Access Compliance Report Public Rights-of-Way (Curb Ramps)

Main Street: CASTLEGATE_LN Cross Street: CASTLEGATE_LN Location: W

ADA ID: RPRK211011111011 Ramp Type: Type 1 - Perpendicular Diagonal Initial Pass/Fail: Fail Overall Compliance: No Severity Score: 16

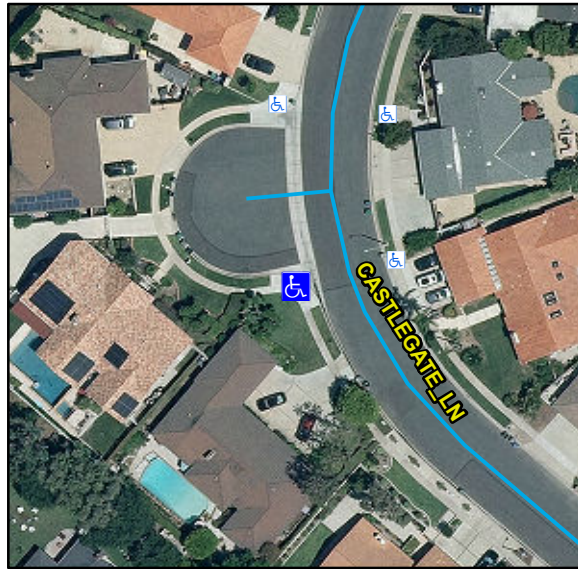
Compliance	Description	Data	Compliance	Description	Data
N/A	Ramp Length (in)	100	N/A	Flare Type LT	
Yes	Ramp Width (in)	48			N/A
No	Ramp Run Slope (%)	11	N/A	Flare Slope LT (%)	N/A
No	Ramp Cross Slope (%)	2.3	N/A	Flare Traversable LT	N/A
N/A	Landing Present	N/A	N/A	Flare Type RT	
N/A	Landing Length (in)	N/A			N/A
N/A	Landing Width (in)	N/A	N/A	Flare Slope RT (%)	N/A
N/A	Landing Run Slope (%)	N/A	N/A	Flare Traversable RT	N/A
N/A	Landing Cross Slope (%)	N/A	N/A	DWS Provided	N/A
N/A	Landing Movement Obstructed?	N/A	N/A	DWS Contrast	N/A
	Landing Movement Type	N/A	N/A	DWS Length (in)	N/A
N/A	Landing Shared	N/A	N/A	DWS Full Width	N/A
N/A	Clear Space	Yes	N/A	DWS Offset Left (in)	N/A
N/A	Clear Space To Crosswalk (in)	N/A	N/A	DWS Offset Right (in)	N/A
N/A	Marked Crosswalk 1	No	N/A	Marked Crosswalk 2	No
	Crossing 1 Direction	E		Crossing 2 Direction	N
	Marked Crosswalk 1 Width (in)	N/A		Marked Crosswalk 2 Width (in)	N/A

N/A	Ramp Inside Crosswalk 1	N/A	Yes	Ramp Inside Crosswalk 2	N/A
	Crossing 1 Slope (%)	9.9		Crossing 2 Slope (%)	0.7
	Crossing 1 Cross Slope (%)	1.4		Crossing 2 Cross Slope (%)	0.1
N/A	Gutter Ponding	N/A	No	Curb Slope	10.6
Yes	Gutter Lip Height (in)	0		Road Run Slope (%)	0.8
N/A	Gutter Run Slope (%)	N/A		Road Cross Slope (%)	5.3
N/A	Gutter Cross Slope (%)	N/A			
Yes	Overall Surface Condition: Acceptable		Yes	Perp Joint Present	Yes
	Cross Gutter Present?	Yes		Spandrel Present?	Yes
	Replace Cross Gutter?	No		Replace Spandrel?	No

Remove & Replace Curb Ramp With Two New Directional Ramps or Equivalent.

R304.2.2, R304.5.3, STD 1115
